Model	Model Code	Model Type
BF250A	BBJJ

Authorized by MATSUMURA HIROYUKI
Power Product Service Engineering Department, Honda Motor Co.,Ltd

Salt Accumulation

Countermeasure 1

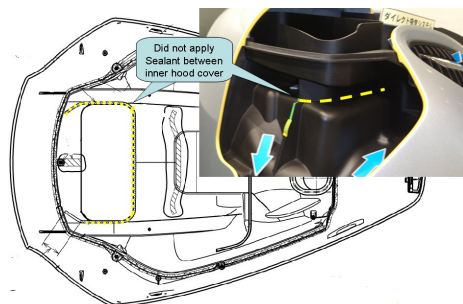
Salt accumulation on various engine parts and inside the engine air intake system.

Due to lack of water proof sealant on inner cover, Inner cover sealant did not perform then water leaked to inside of engine.

Apply sealant on inner hood cover.(factory forgot to apply sealant)

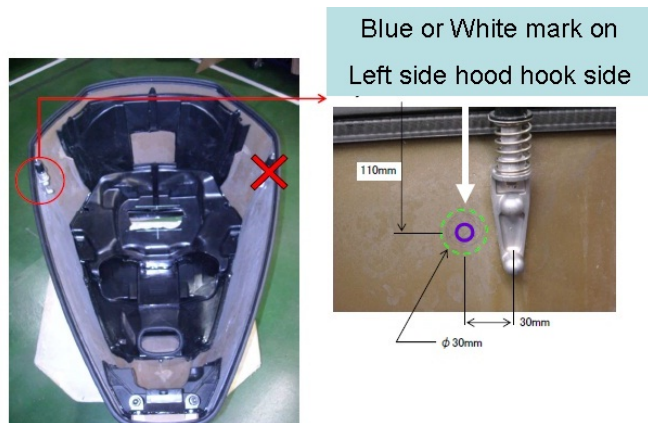
Countermeasure engine hood cover indicated paint mark as following area,

Replace with C/M engine hood cover after cleaning the engine.
